DSP-16032-01
DDS-643
AC-17006-01

STAFF REPORT

SUBJECT: Detailed Site Plan DSP-16032-01
Departure from Design Standards DDS-643
Alternative Compliance AC-17006-01
SMO, Incorporated

DETAILED SITE PLAN

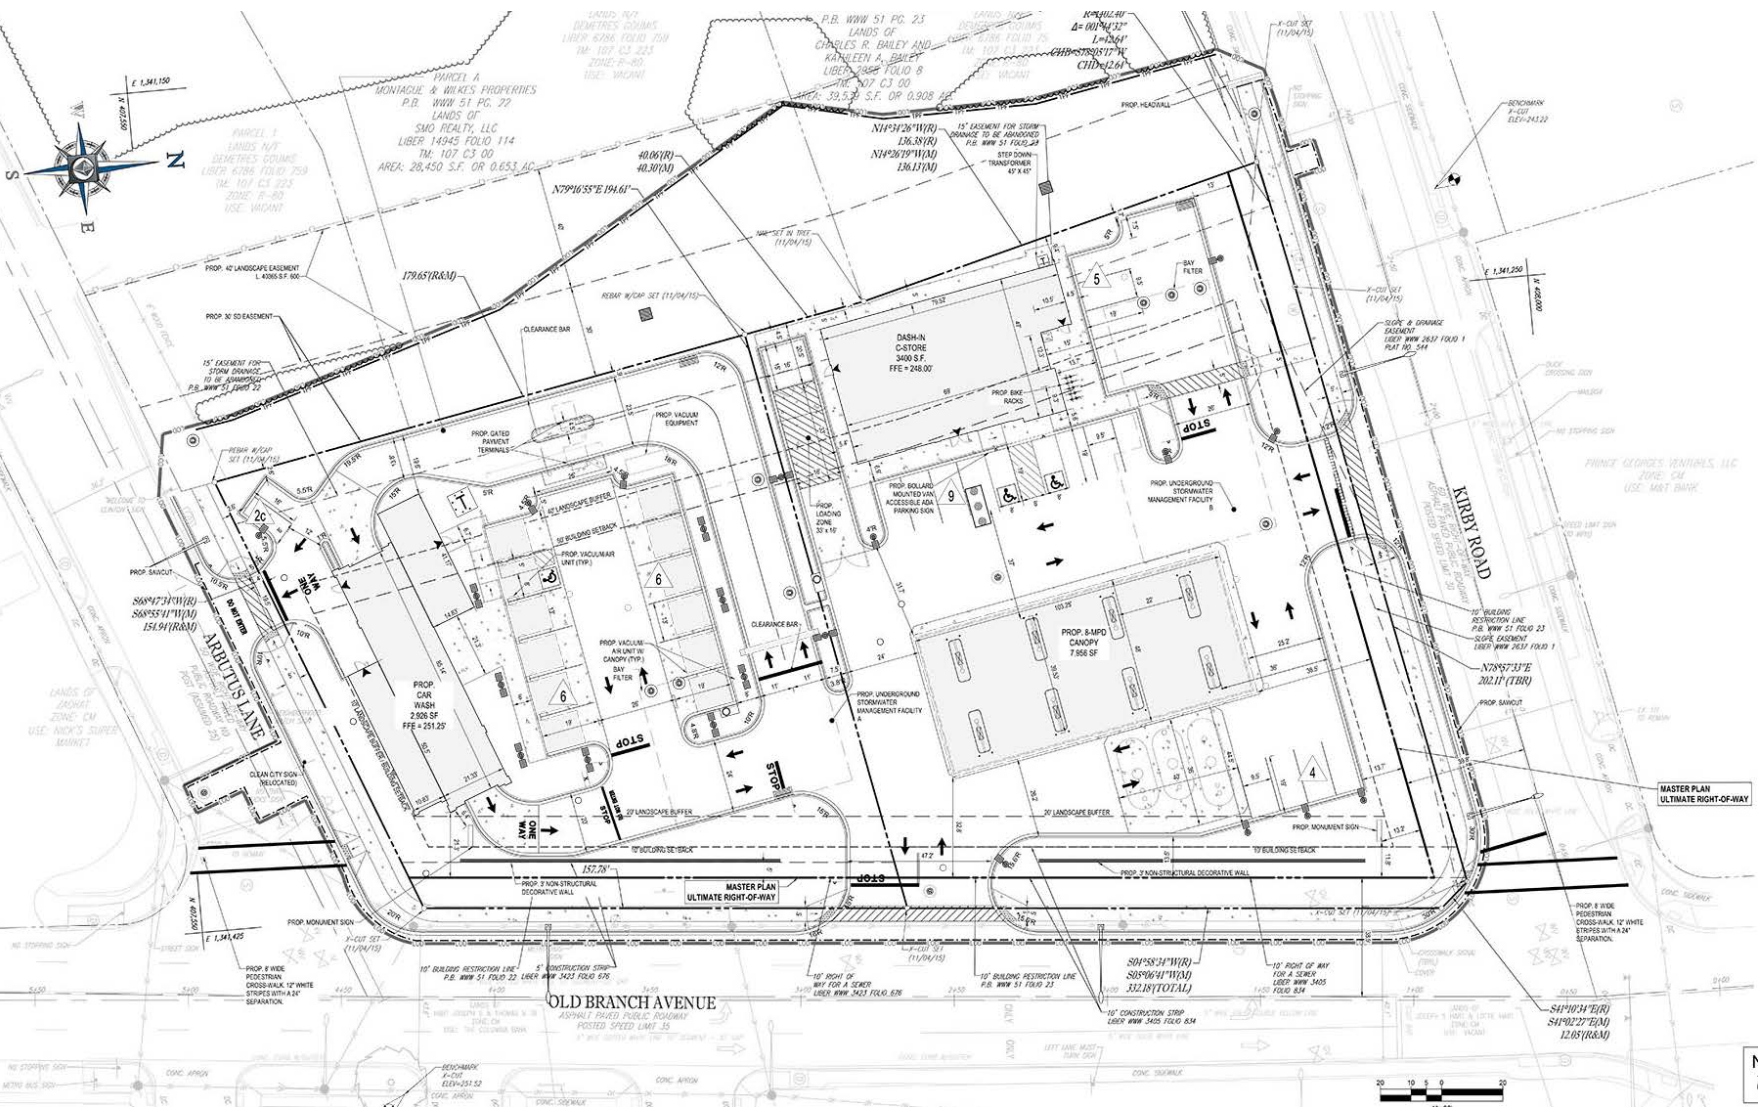
- a. Replace the four-foot-high chain-link fence, which is to be removed, with a six-foot-high, sight-tight, composite fence.
 - b. Revise the plans to indicate the square footage/area and dedication of land for public use along Kirby Road and Old Branch Avenue.

- c. Remove the proposed trees out of the ultimate right-of-way along all frontages.
 - d. Remove the “Loading Zone Parking” from the proposed parking summary, recalculating the total number of proposed parking spaces.

1. The applicant is proposing right-of-way dedication along Kirby Road and Old Branch Avenue. The area of dedication is reflected in the General Notes section. However, the plans should be revised to indicate the dedication of land for public use, including the square footage/area, along Kirby Road and Old Branch Avenue.

1. Prior to certification of the detailed site plan, revise the plans to indicate the square footage/area and dedication of land for public use along Kirby Road and Old Branch Avenue.
